Work Order ID 150274

Item Name: Doubler

APICAL INDUSTRIES, INC.	ENGINEERING CHANGE NOTICE NO. 03985			SHEET 1 OF 2	
	DWG NO. 647.0100	REV: A	PREPARED BY J. BECKER	DATE: 7/15/13	EFFECT ON DWG ☐ INC. ☒ UNINC.
	DWG TITLE: SHEET METAL				
	APPROVED BY: ENGR. 	MFG 	QC 	EFF. NEXT ORDER	
TRANSACTION CODES (TC): A-ADD R-REVISE C-CREATE D-DELETE	REASON: REVISED NOTE 2. ADDED 647.0117

SHEET 1, ZONE D1 IS:

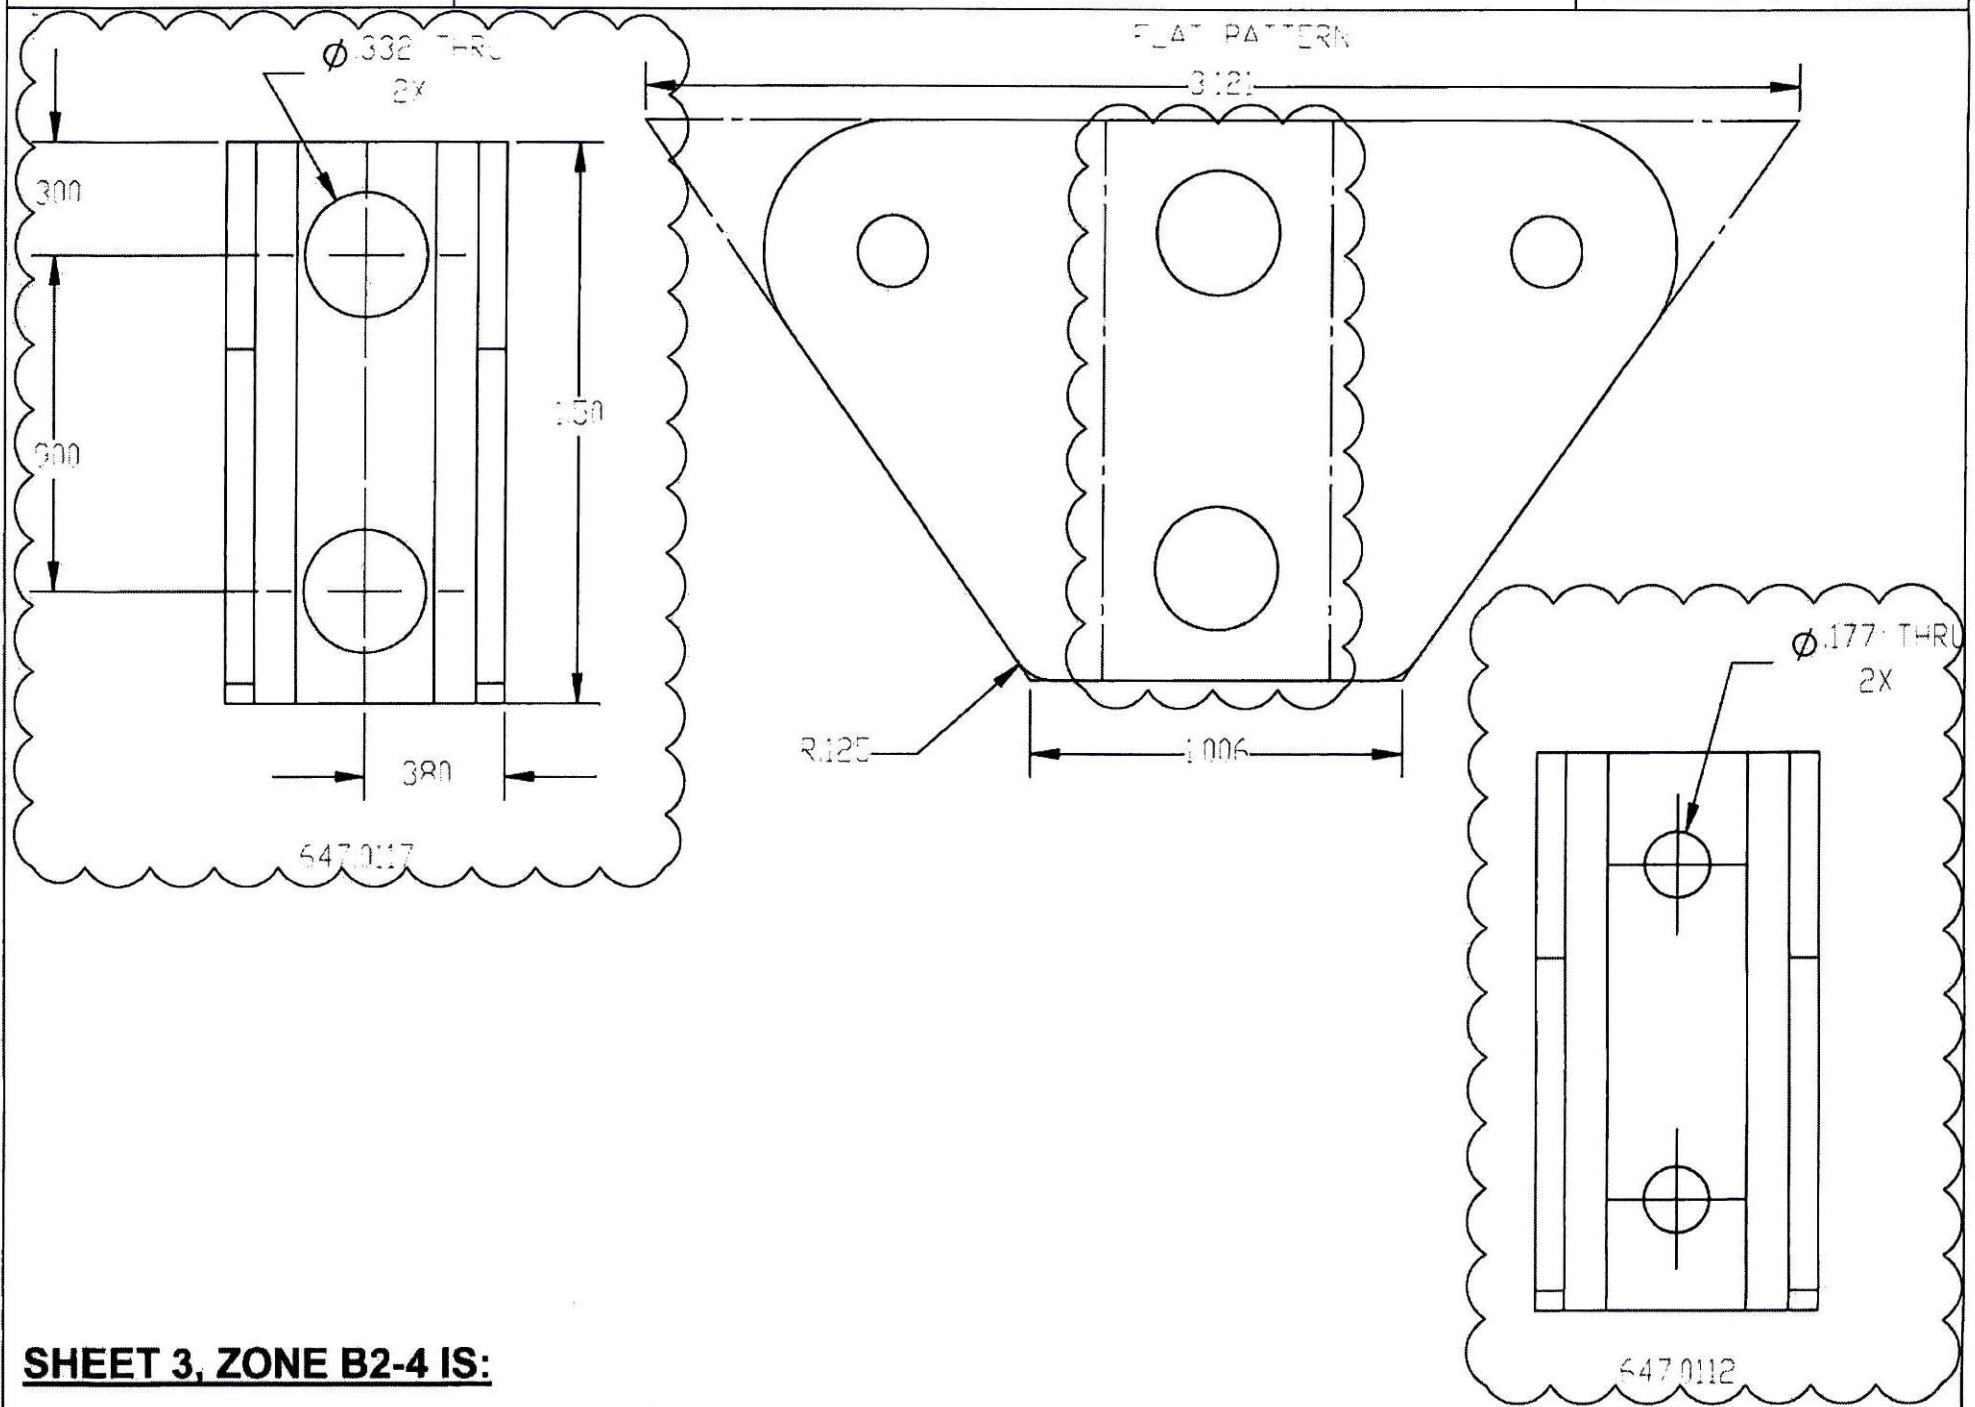
- 1 MATERIAL: ALUMINUM 2024-T3 PER AMS-QQ-A-250/4.
- 2 FINISH: IAW MPP-172 ANODIZE IAW SECTION 2.1, PRETREATMENT IAW SECTION 3.1 AND PRIMER IAW SECTION 4.1.
- 3. DEBURR AND BREAK ALL SHARP EDGES.
- 4. IDENTIFY IAW MPP-120.
- 5 MATERIAL: 304 SS IAW AMS 5643.
- 6 FINISH: PRIME IAW MIL-P-23377J TYPE I CLASS N.
- 7 OTHER DIMENSIONS SAME AS 647.0112.

SHEET 3, ZONE B2-4 IS:

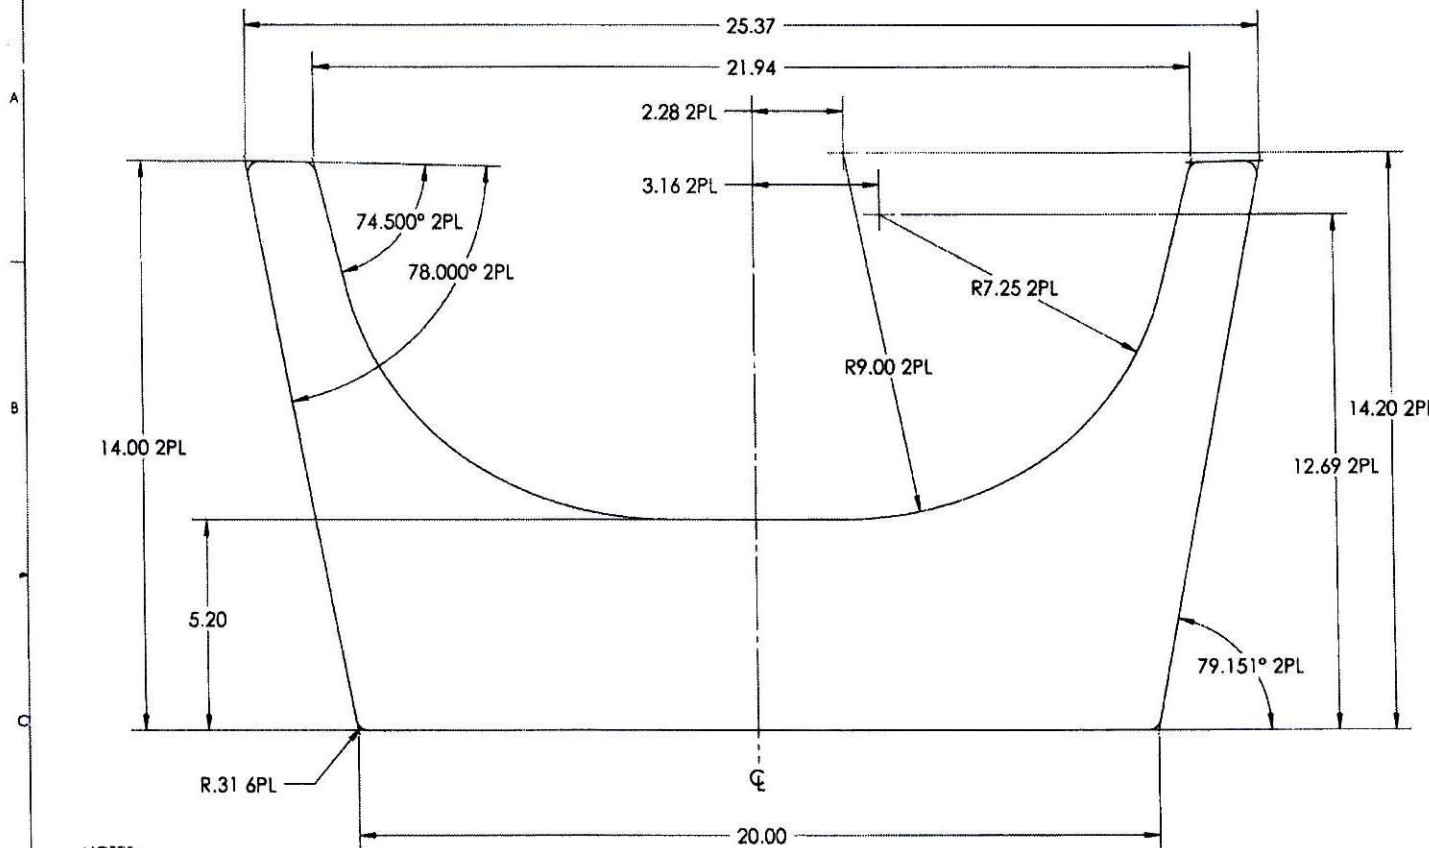
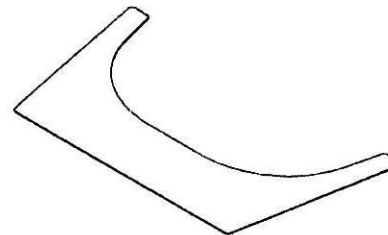
- 1 MATERIAL: ALUMINUM 2024-T3 PER AMS-QQ-A-250/4.
- 2 FINISH: HARD ANODIZE IAW MIL-A-8625 TYPE III, CLASS 2, COLOR BLACK; PRETREAT PR-148 ADHESION PROMOTER; PRIME IAW MIL-P-23377 J TYPE I CLASS N.
3. DEBURR AND BREAK ALL SHARP EDGES.
4. IDENTIFY IAW MPP-120.
- 5 MATERIAL: 304 SS IAW AMS 5643.
- 6 FINISH: PRIME IAW MIL-P-23377 J TYPE I CLASS N.
